**Design Review Committee
March 14, 2013**

SUBJECT: **Case 18354: Substantive Site Plan Approval – Addition to Scotia Square, corner of Duke and Albemarle Streets, Halifax**

SCOTIA SQUARE
WESTHILL ON DUKE

ENTRANCE LEVEL STREET WALL SETBACK PLAN
1/16" = 1'-0"

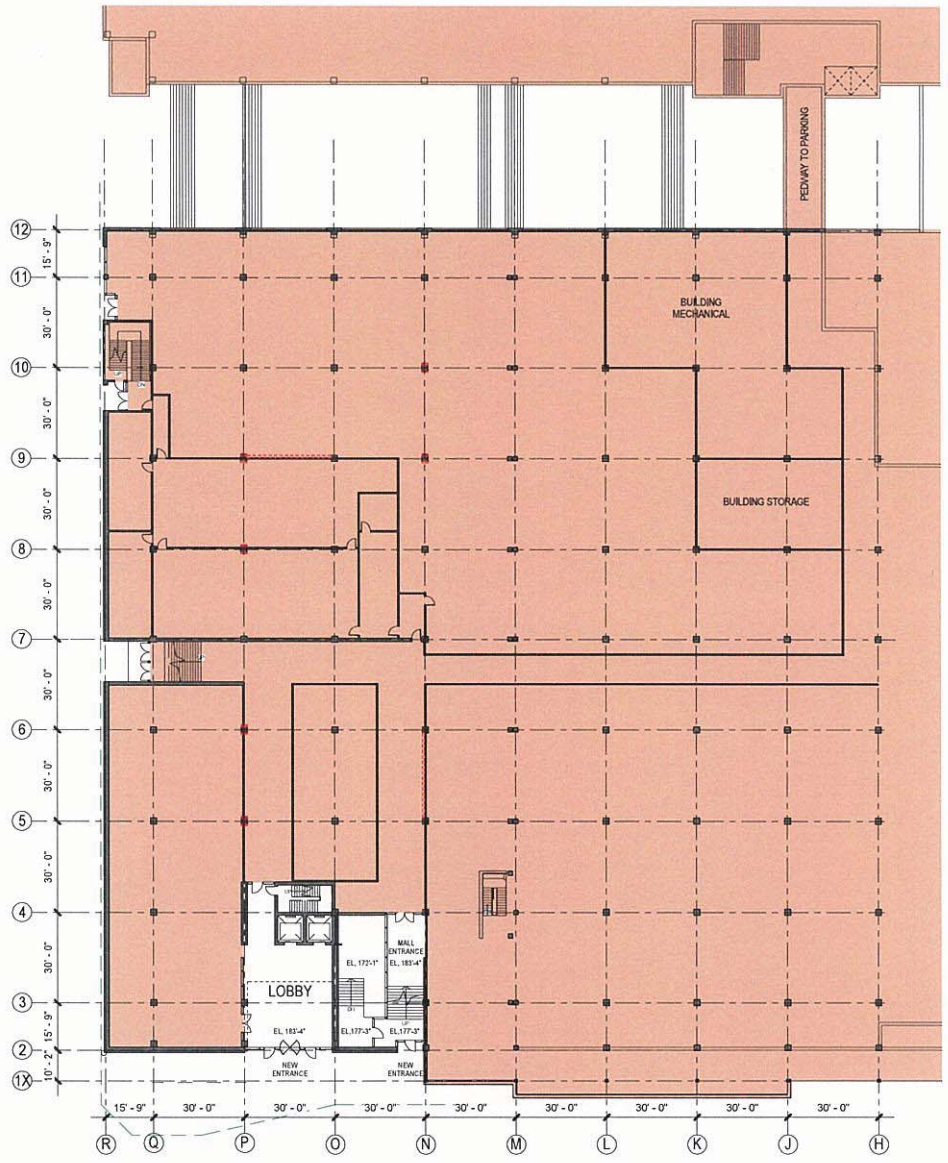
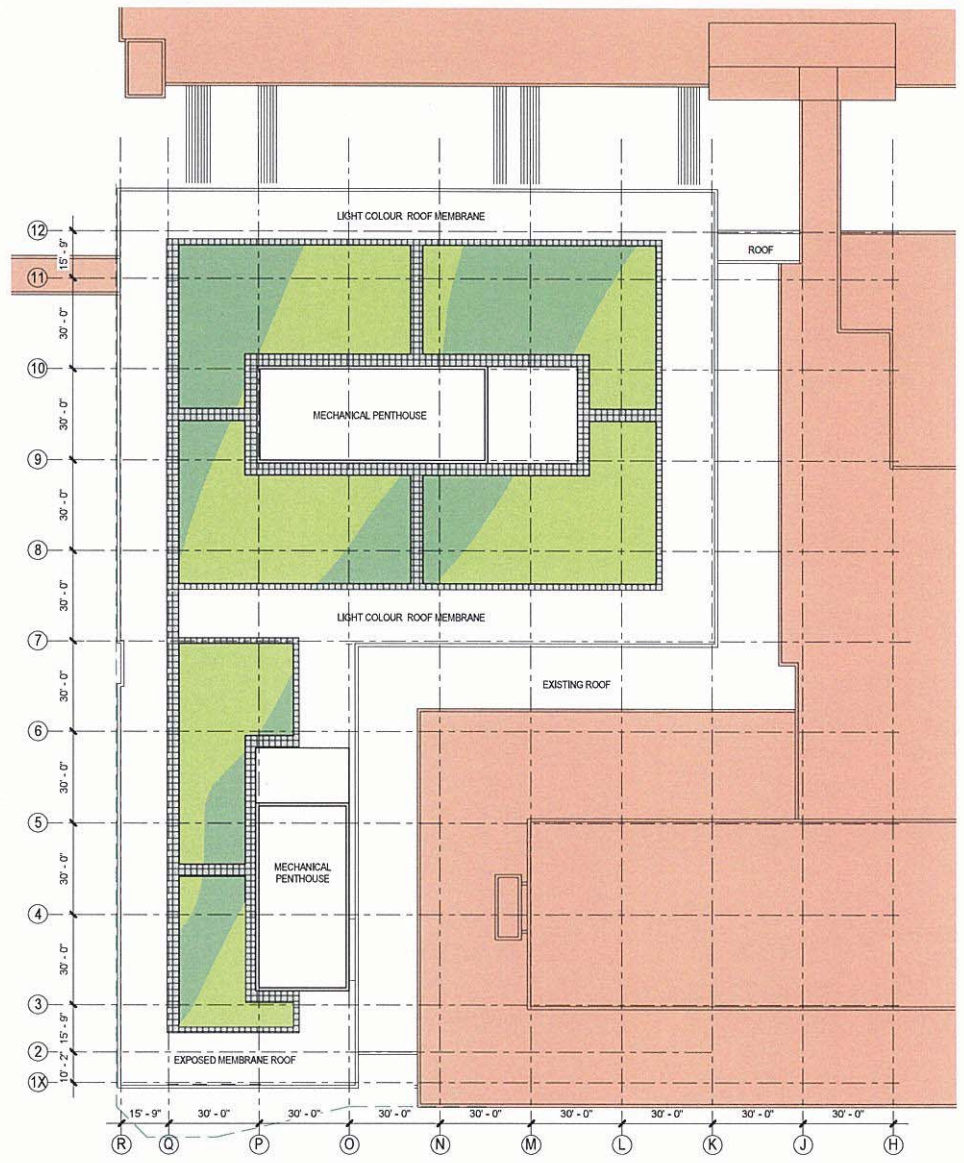
There is one variance being sought to the quantitative elements of the Land Use By-law for this development, relative to the maximum streetwall setback from Duke Street. The required setback pursuant to the LUB is between 0 and 1.5 metres. The Duke Street right of way includes a unique jog in a southward direction near the intersection of Duke and Albemarle Streets (refer to Attachment A). The existing building foundation (not including the existing planter) is approximately 27 feet (8.3m), at its greatest dimension, from the Duke Street property line. The proposed two upper levels of the addition will cantilever southward and closer to the street, resulting in a setback of approximately 16 feet (4.9m) from the streetline. Therefore, a variance is required.

The variance request is relatively minor and reasonable, given the streetline configuration. As the upper levels of the addition are proposed to be closer to the street, an improvement in the streetwall location is achieved. Overall, the proposal results in an improvement in the streetwall for this portion of the block.
